WEST WHITELAND TOWNSHIP
Planning Commission
Agenda
Tuesday, August 18, 2020
7:00 P.M.

MEMORANDUM

SUBJECT: **Exton Knoll**
Land development plan

RE: Exton Knoll (891, 901 & 921 E. Lincoln Highway)
Preliminary / Final Subdivision and Land Development Plan
SSM File 101008.0335

S-05

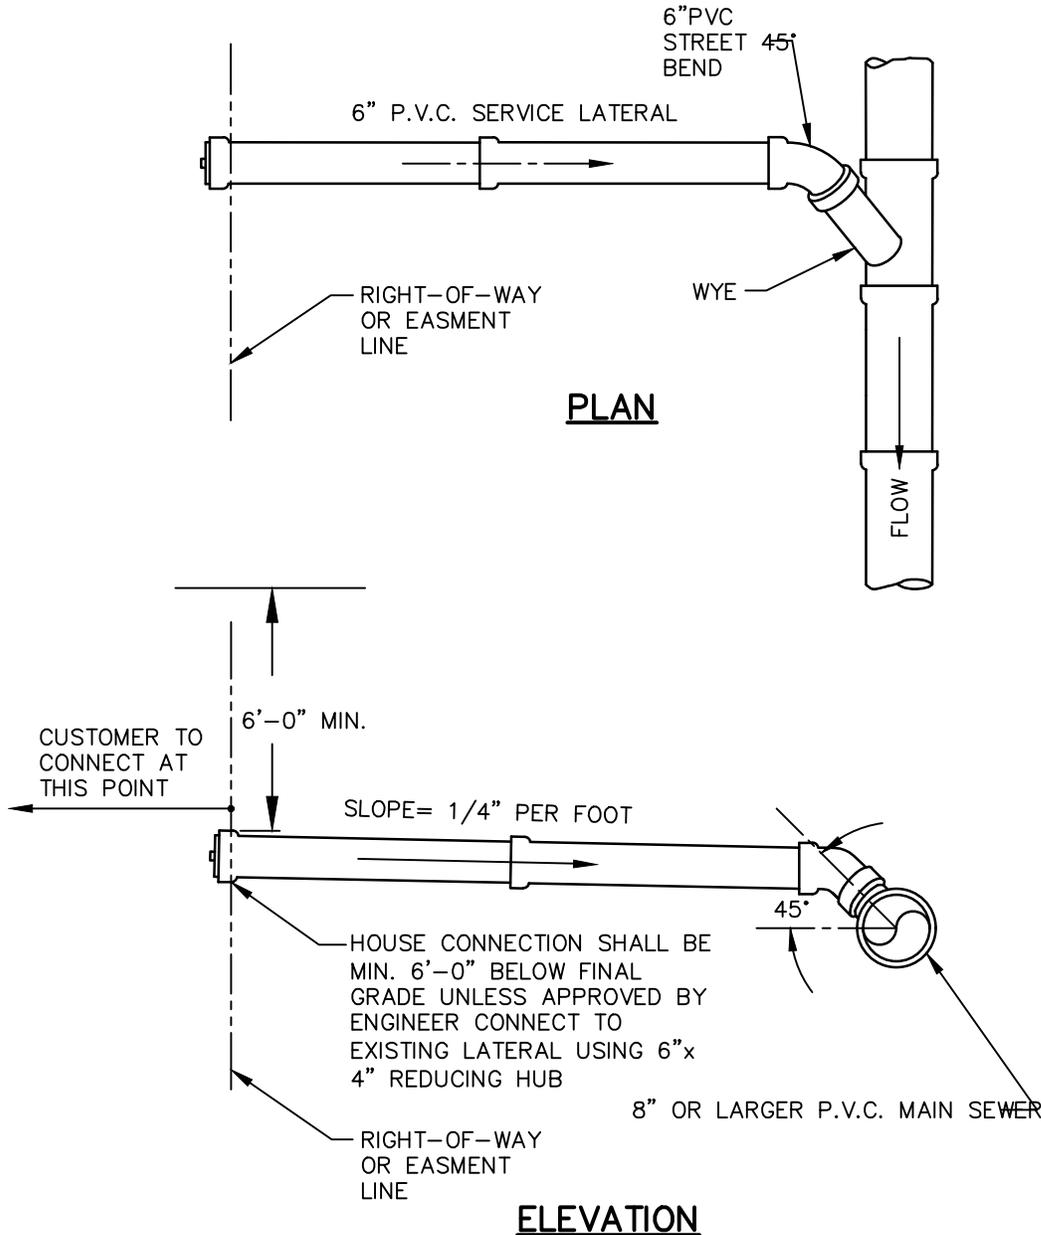
32. Manhole MH S3 shall be labeled as a drop manhole.
33. The following West Whiteland Township/SSM details shall be added to the plan:
 - a. S-05: Typical Service Lateral connection to P.V.C. Main

S-27

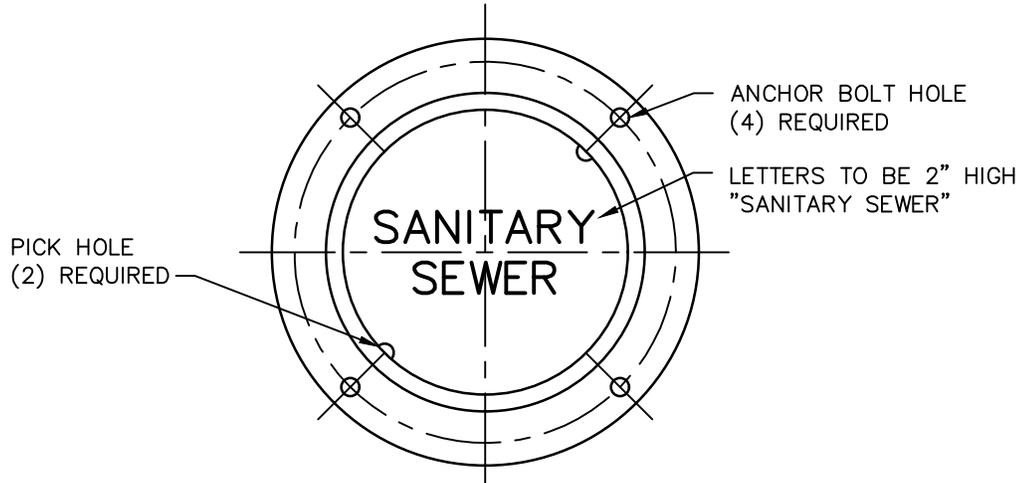
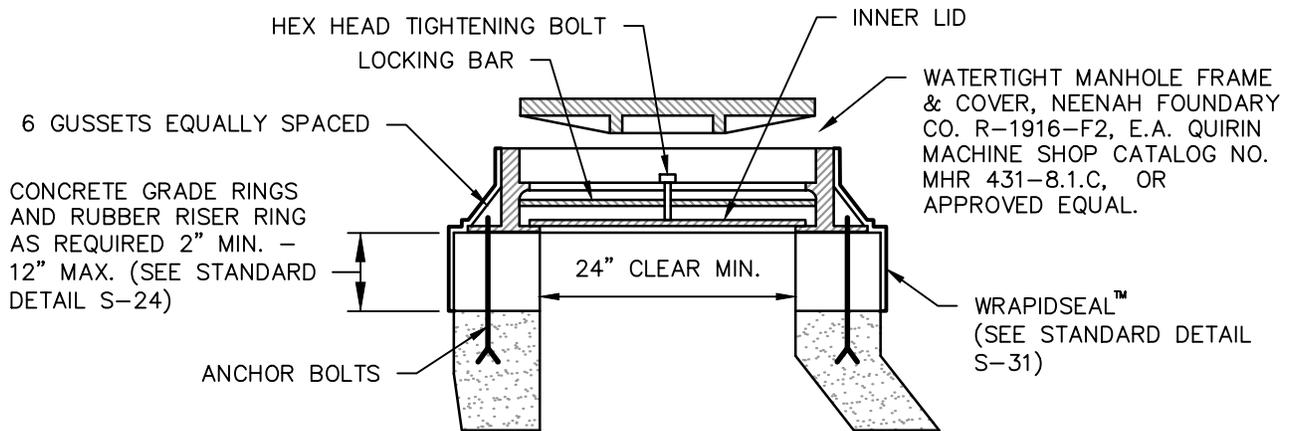
- e. S-27: Watertight Manhole Frame and Cover Installation – Inner Sealing Lid
 - f. S-28: Manhole Anchor Bolt Detail – Stainless Steel
 - g. S-31: Heat Shrinkable Manhole Seal
